SkyWater Technology Foundry Proposed Expansion

DRC – Submission: Project Narrative

Application Number: PL201900127

SUBJECT: **Application: PL201900127**
 SkyWater Technology Foundry, Inc.
 2401 and 2411 East 86th Street
 Pre-Application DRC Comments – June 25, 2019: **Responses**

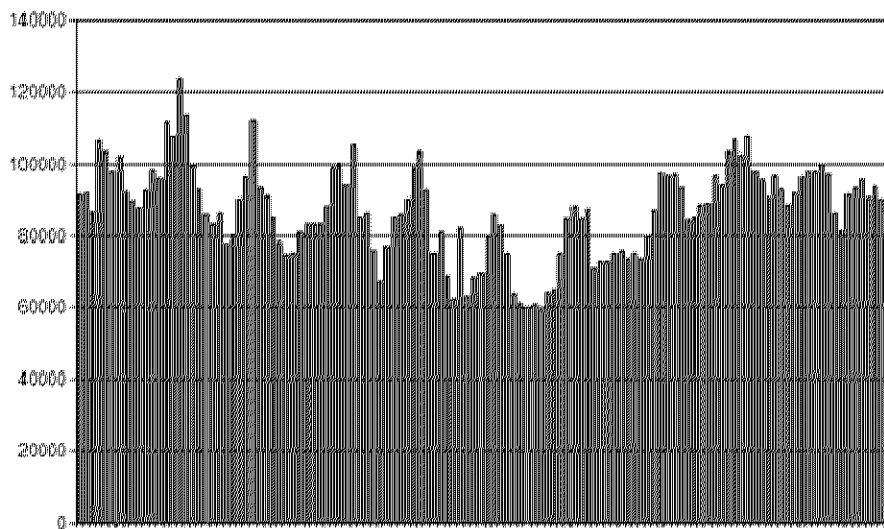
6. If meter data isn't possible would Skywater please share pumping data regarding pump starts and durations? Again this is to get an idea of the flow parameters from Skywater.

SkyWater does not have pump start and duration records. Only a totalizer for run time on each pump.
